SERVICE BULLETIN

Service Bulletin No. 665

SUBJECT: Heat Shield Removal

MODELS AFFECTED: TEO-540-C1A

Figure 1
Removal of Heat Shield

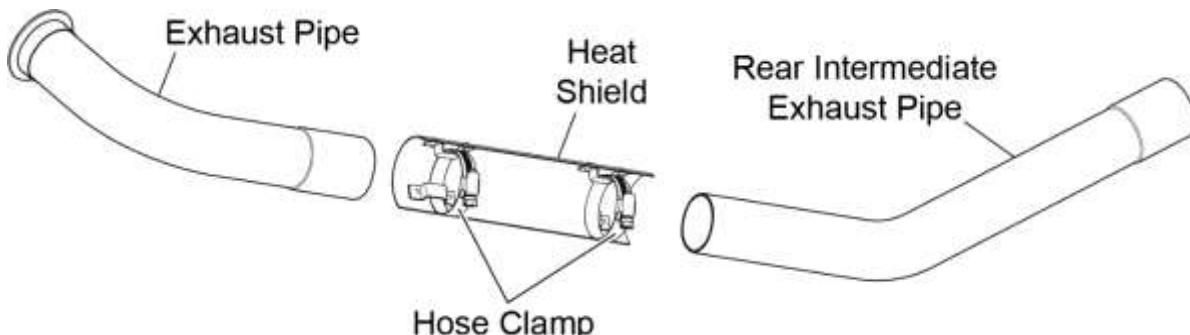
Lycoming has determined that the heat shield (P/N LW-16406) installed between the Exhaust Pipe and Rear Intermediate Exhaust Pipe (Figure 1) could restrict the movement of the pipes and prevent the exhaust system slip joints from functioning properly.

Remove and discard the heat shield and hose clamps in accordance with instructions in the latest revision of the **TEO-540-C1A Engine Maintenance Manual**.
